9/13/96	Class B Concrete changed to Class A.
6/14/96	Notes added to clarify plans.
DATE	REVISION
STATE OF HAWAII DEPARTMENT OF TRANSPORTATION HIGHWAYS DIVISION	
DRAINAGE PLAN	
KALANIANA'OLE HIGHWAY RESURFACING	
Kailua Rd. to Hilo St.	
Project No. 72A-01-96M	
Scale: 1"=40'	Date: May 1996
SHEET No. 44 OF 44 SHEETS

KALANIANA'OLE HIGHWAY RESURFACING

Project No. 72A-01-96M

FED. ROAD DIST. NO.	STATE	FED. AID PROJ. NO.	FISCAL YEAR	SHEET NO.	TOTAL SHEETS
HAWAII	HAW.	72A-01-96M	1996	C.O. 55S-11	55

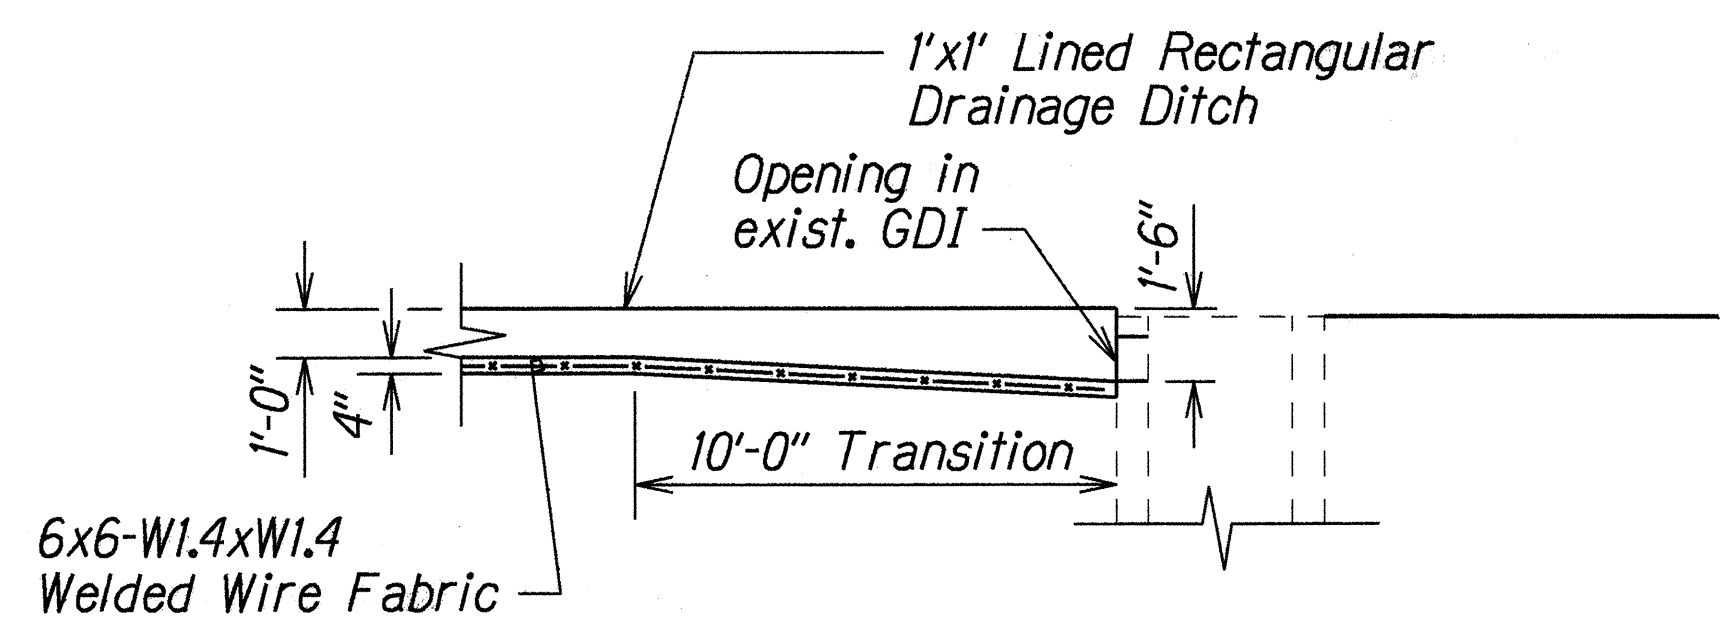
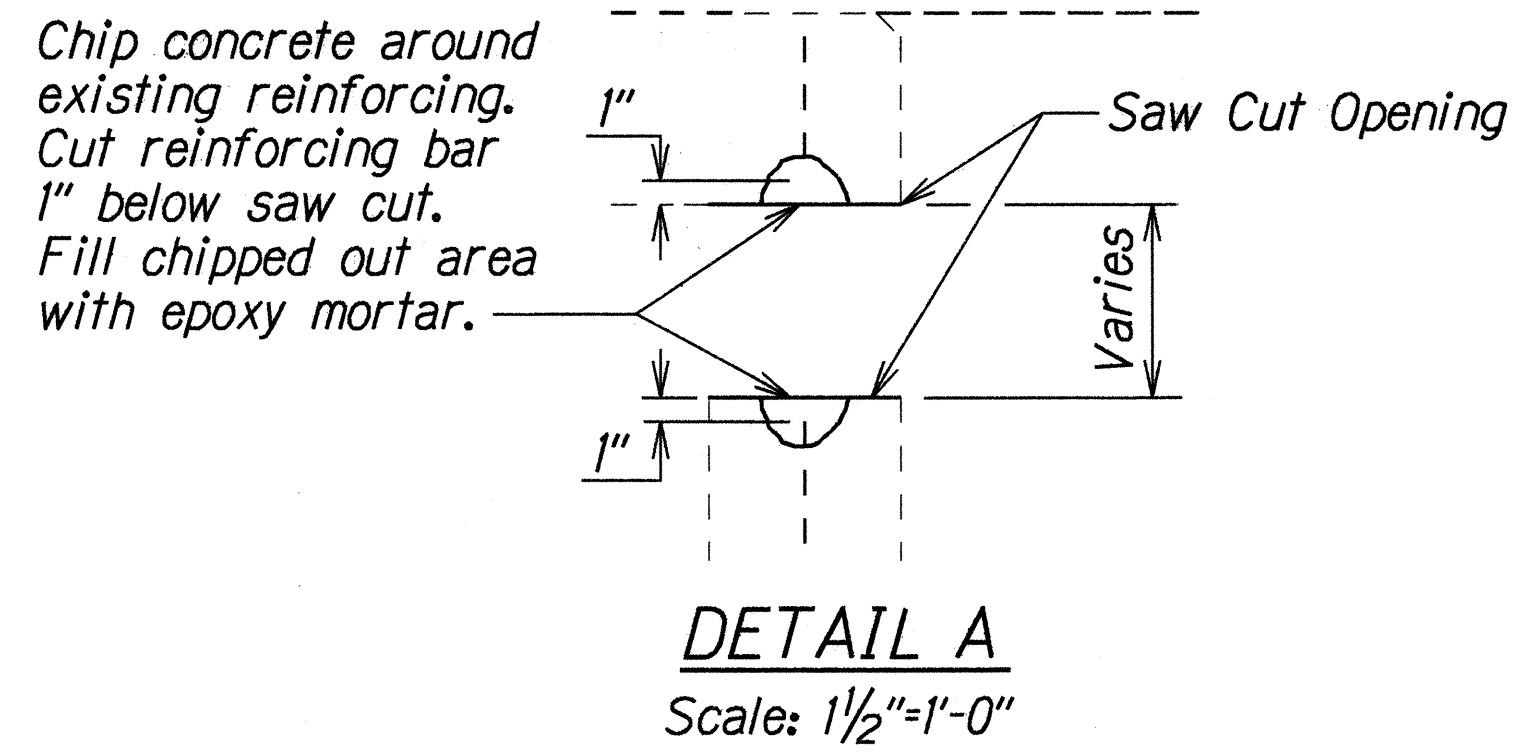
12/5/96	Delete Portion of 1'x1' Lined Rectangular Drainage Ditch.
9/13/96	Sheet added to show details of 1'x1' Lined Rectangular Drainage Ditch.
DATE	REVISION
STATE OF HAWAII DEPARTMENT OF TRANSPORTATION HIGHWAYS DIVISION DRAINAGE DETAILS KALANIANA'OLE HIGHWAY RESURFACING Kailua Rd. to Hilu St. Project No. 72A-01-96M Scale: As Shown Date: Jul. 1996 SHEET No. H12K OF 12 SHEETS

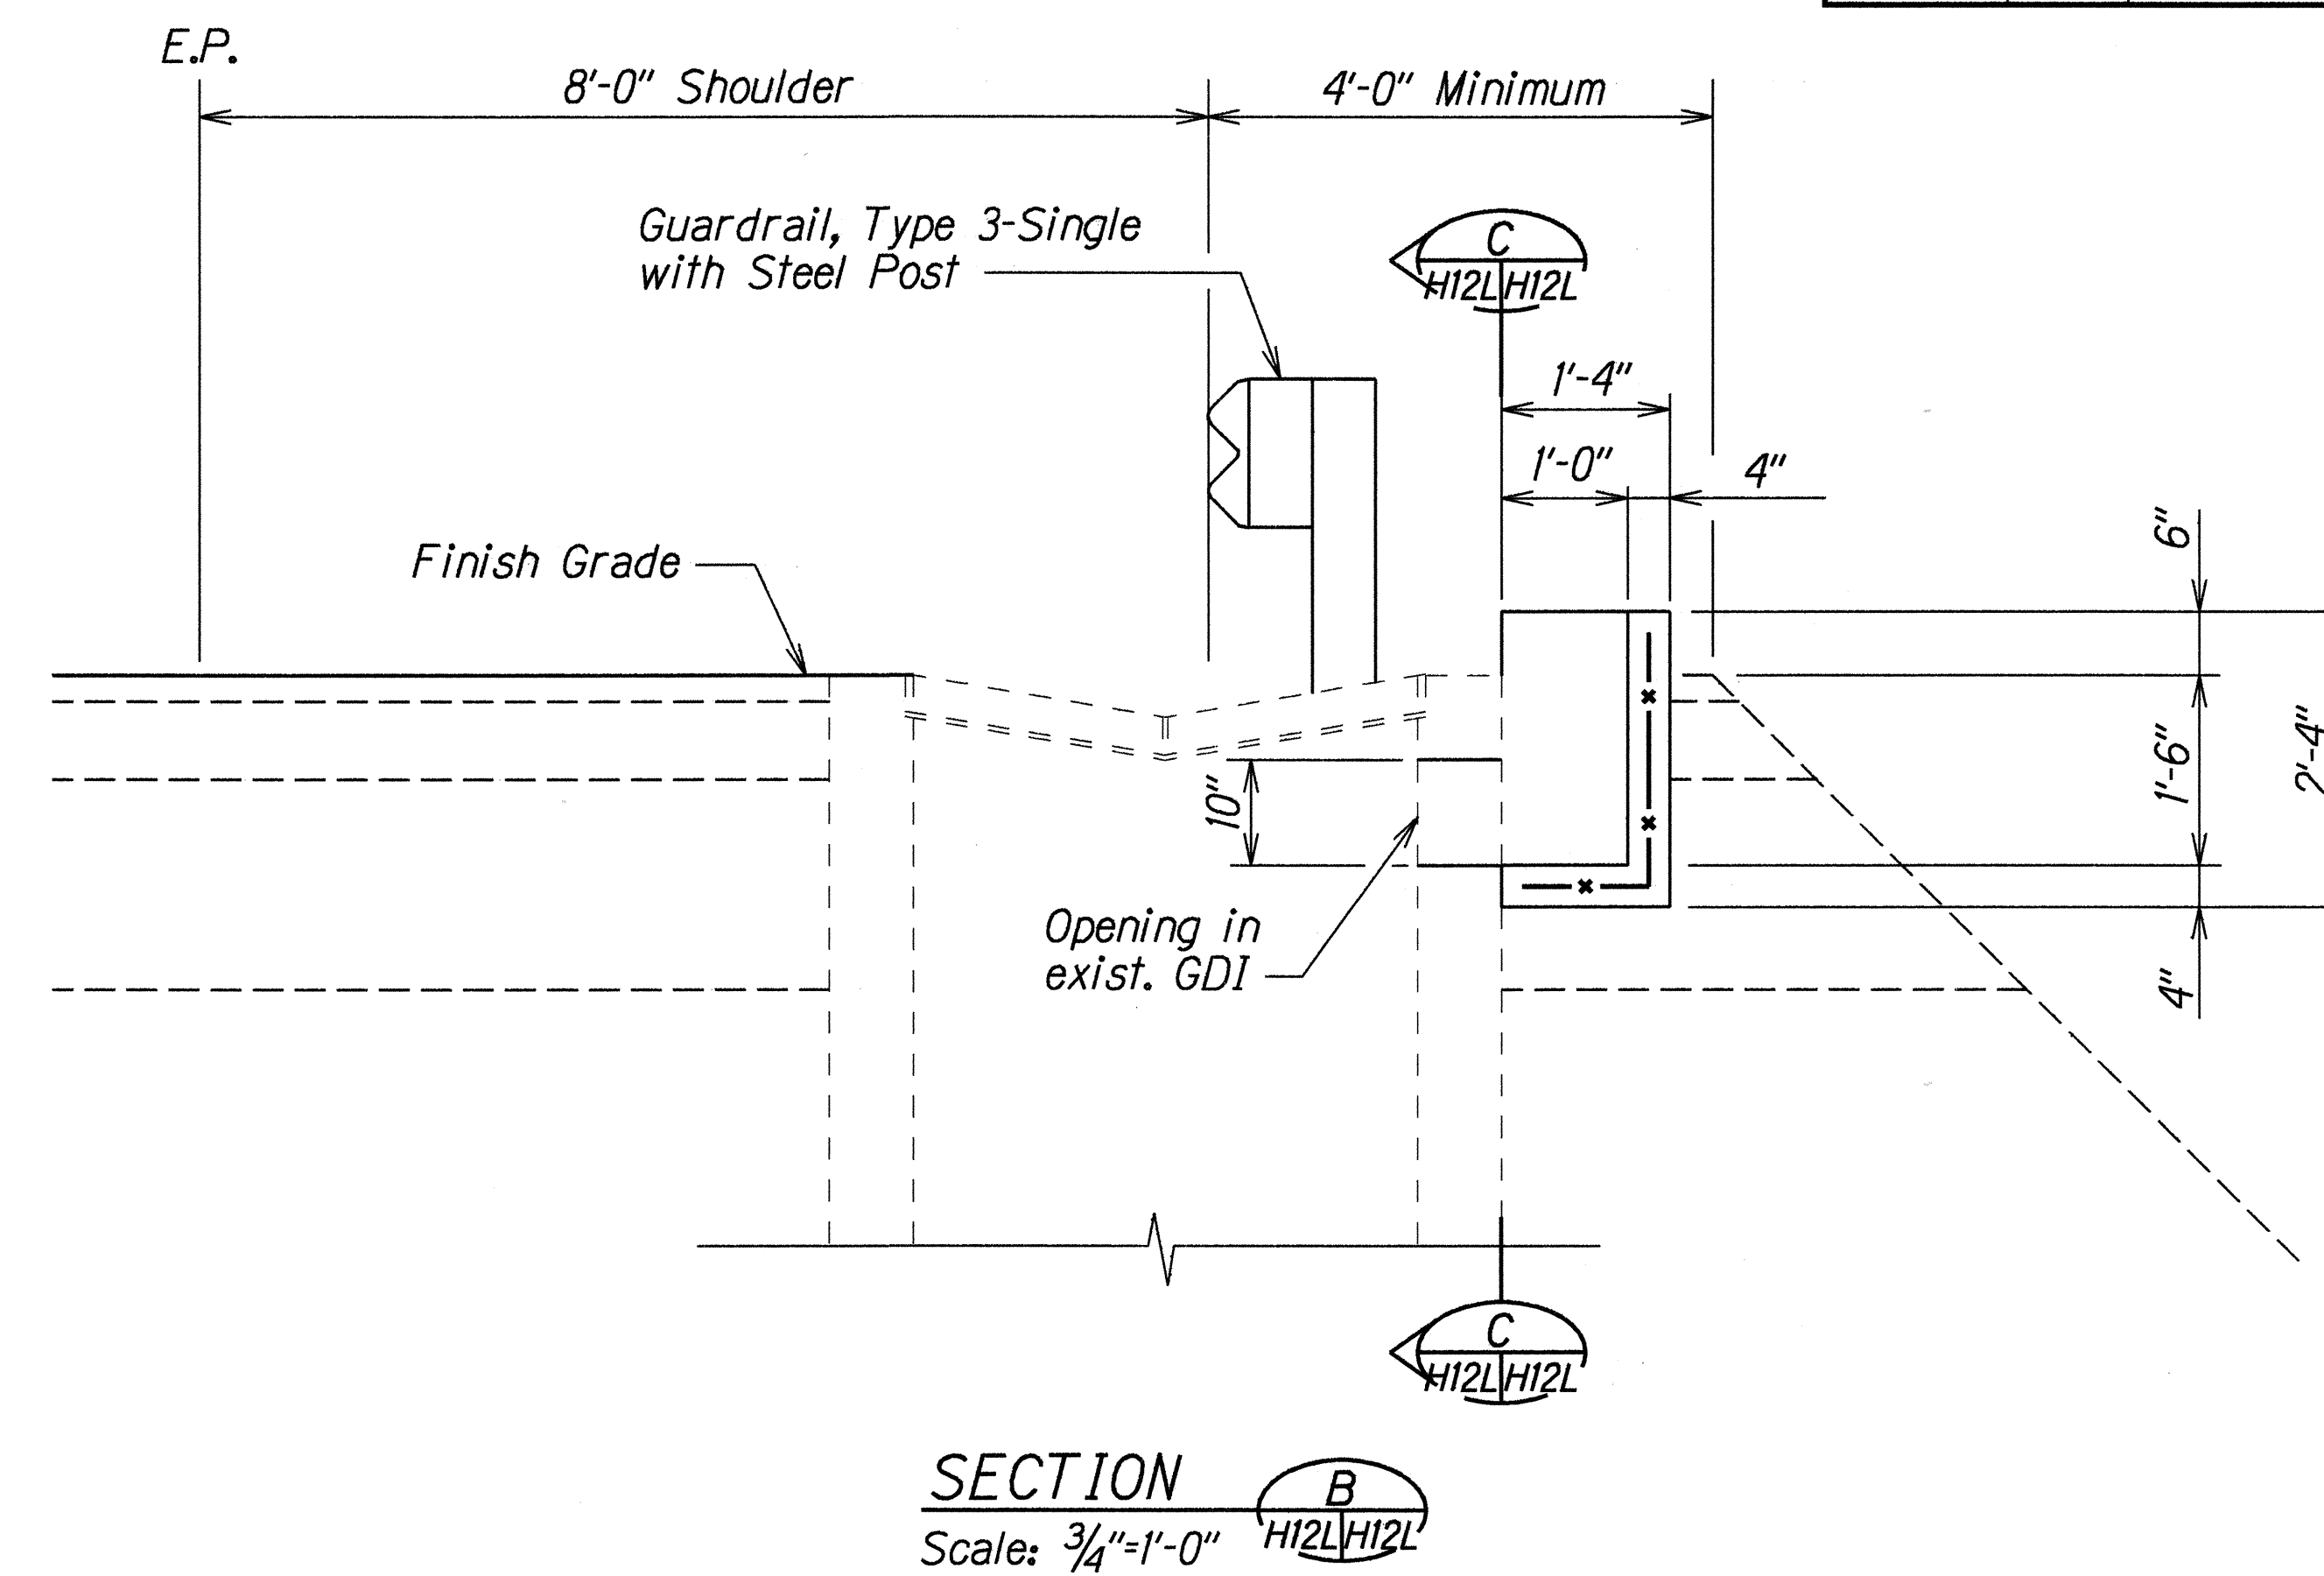
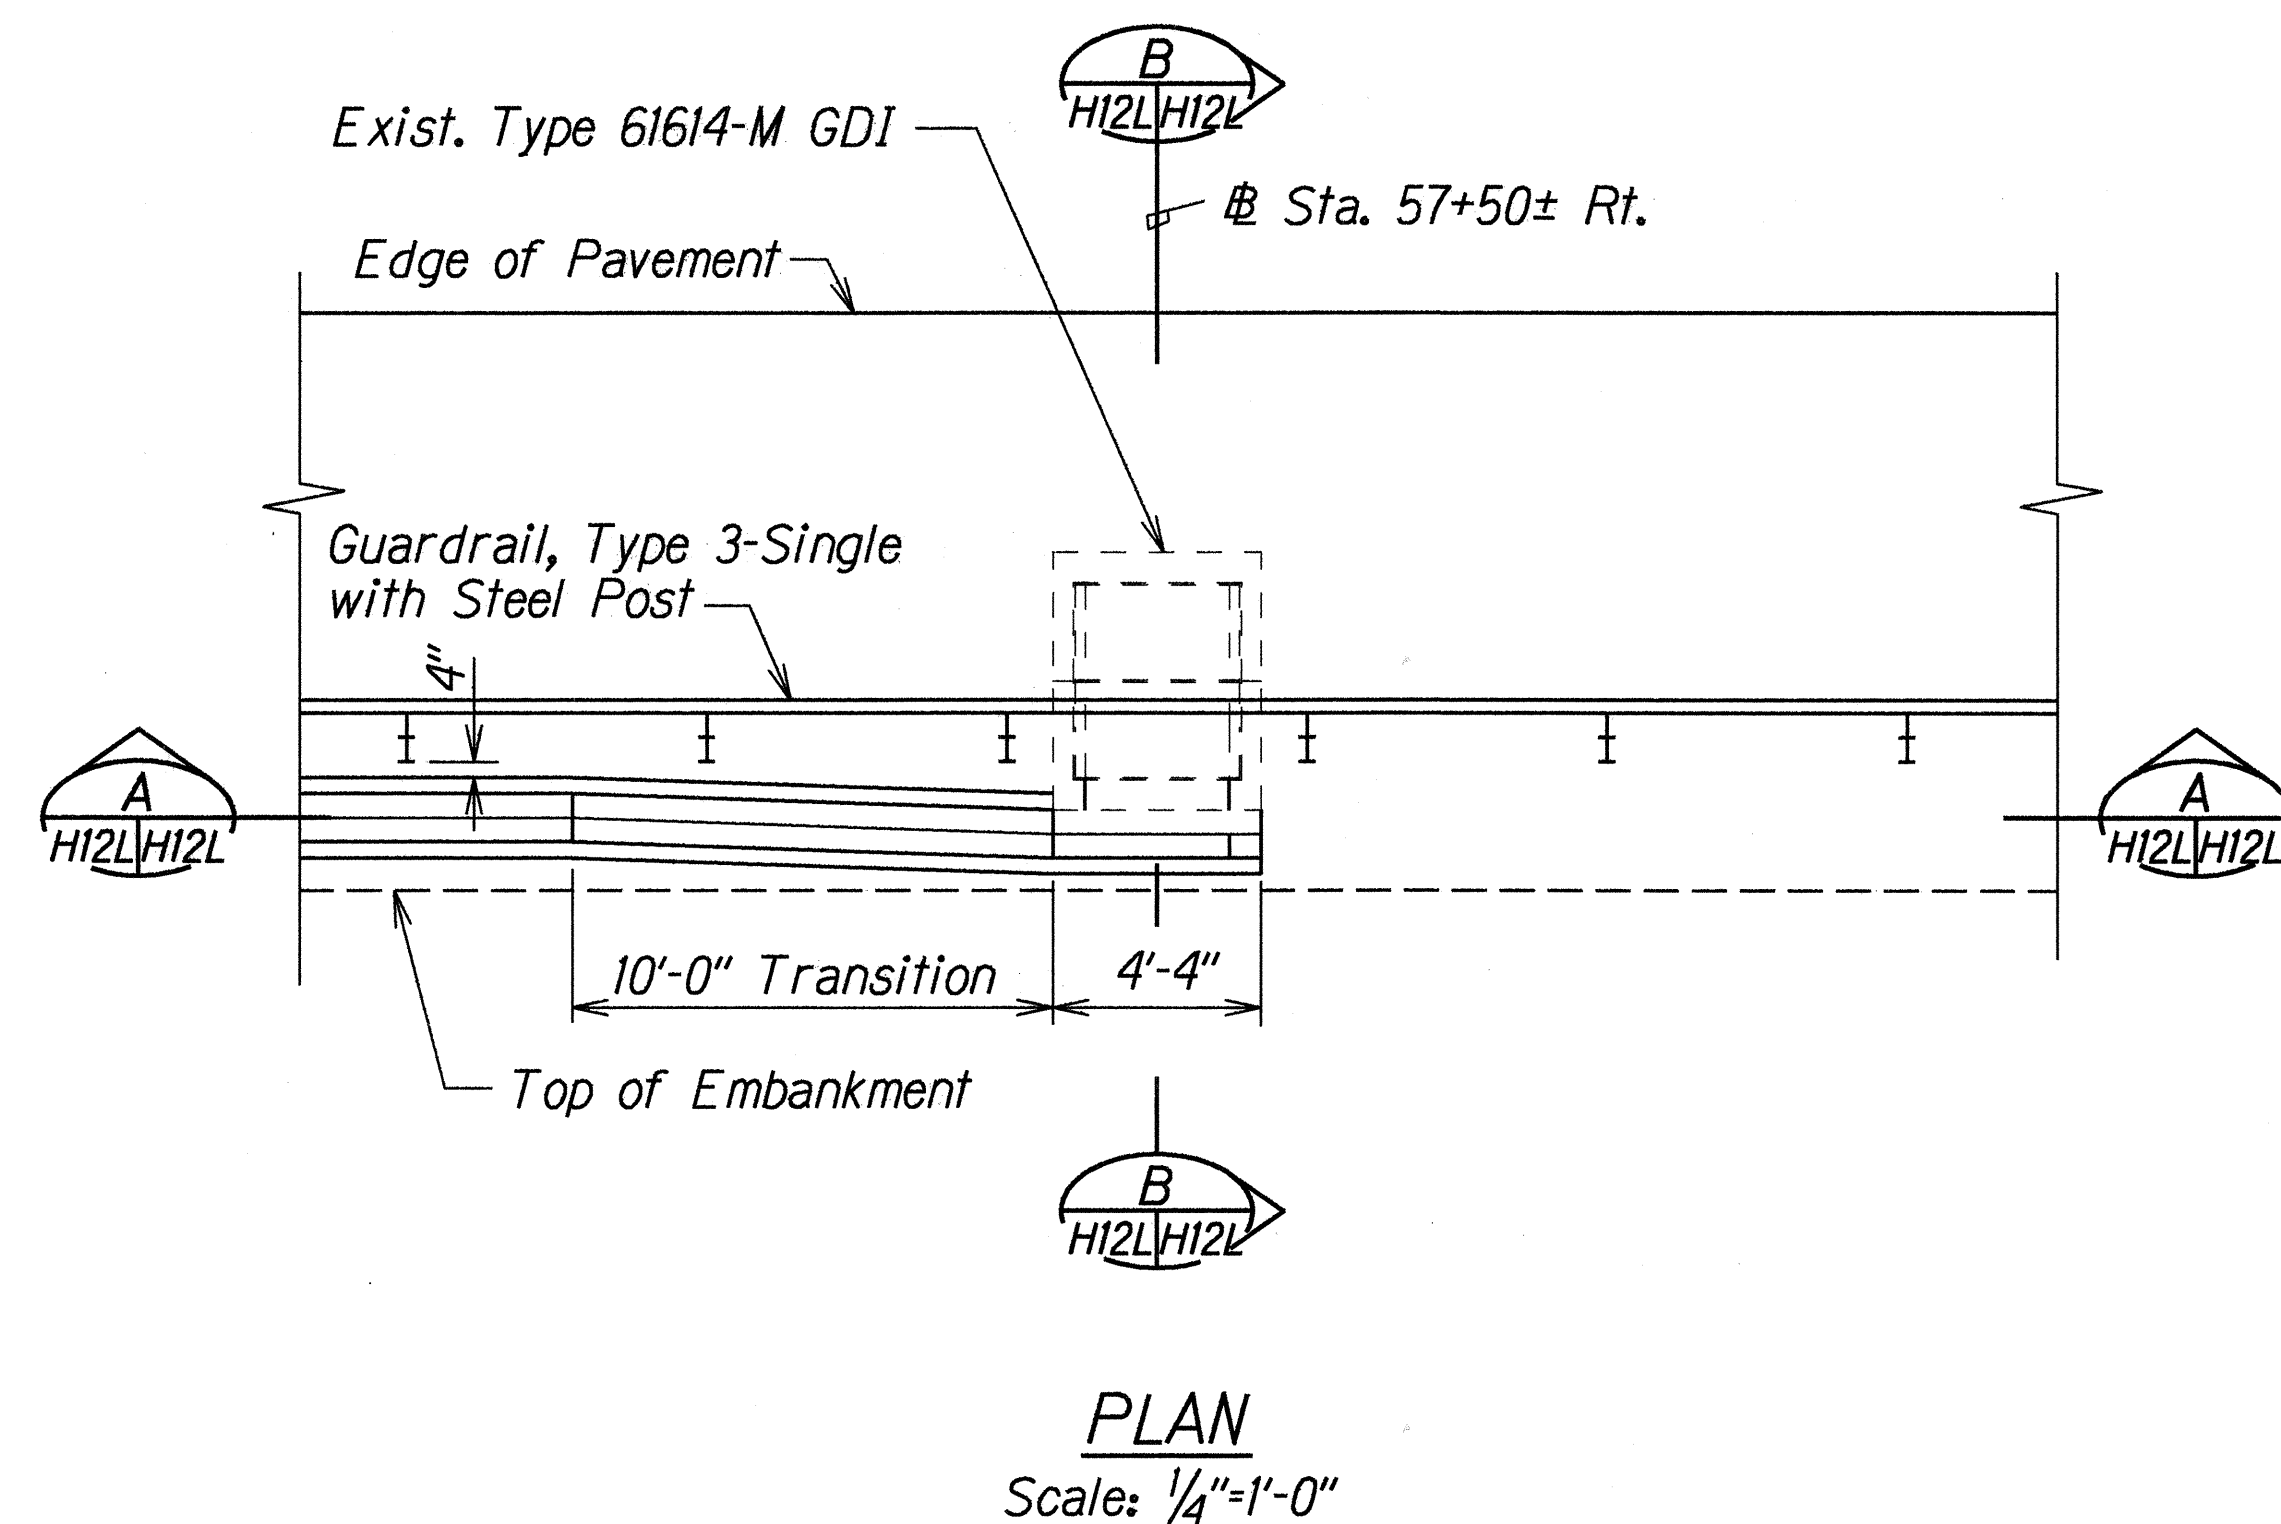
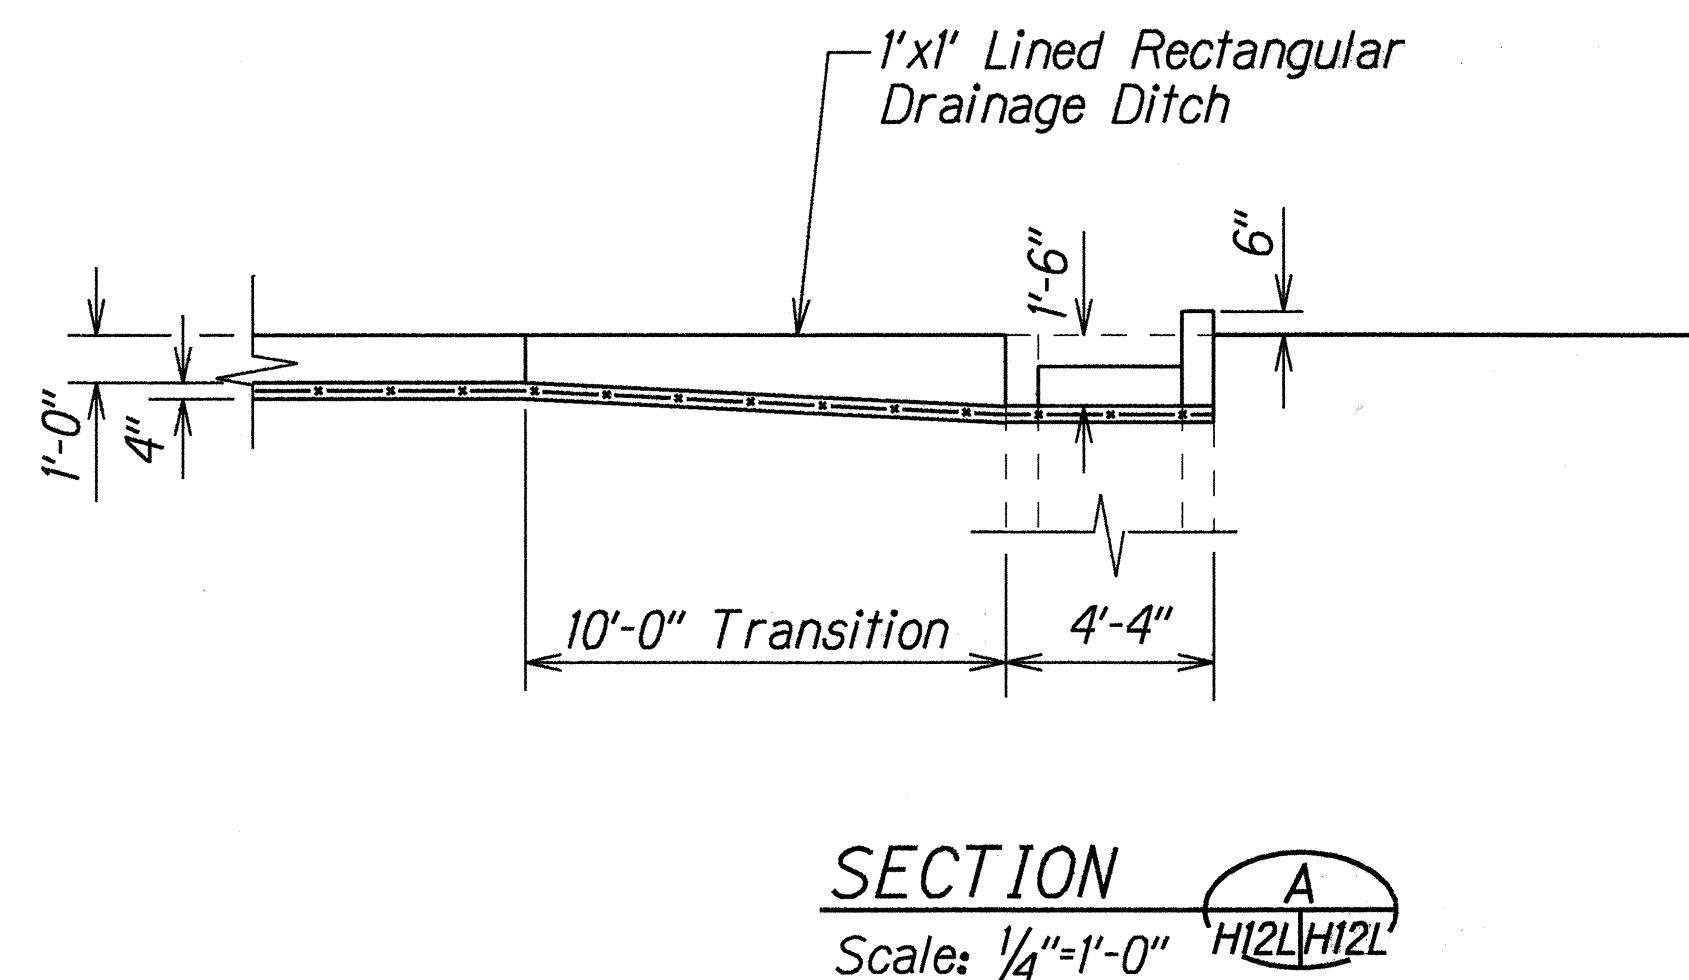
12/5/96	Revised Transition of 1'x1' Lined Rectangular Drainage Ditch.
9/13/96	Sheet added to show details of 1'x1' Lined Rectangular Drainage Ditch Transition at Sta. 57+50± Rt.
DATE	REVISION
STATE OF HAWAII DEPARTMENT OF TRANSPORTATION HIGHWAYS DIVISION	
<u>DRAINAGE DETAILS</u>	
KALANIANA'OLE HIGHWAY RESURFACING	
Kailua Rd. to Hilu St.	
Project No. 72A-01-96M	
Scale: As Shown	Date: Jul. 1996
SHEET No. H12L OF 12 SHEETS	
C.O. 55S-12

NOTE:
Constructing saw cut opening in existing GDI shall be considered incidental to the 1'x1' Lined Rectangular Drainage Ditch
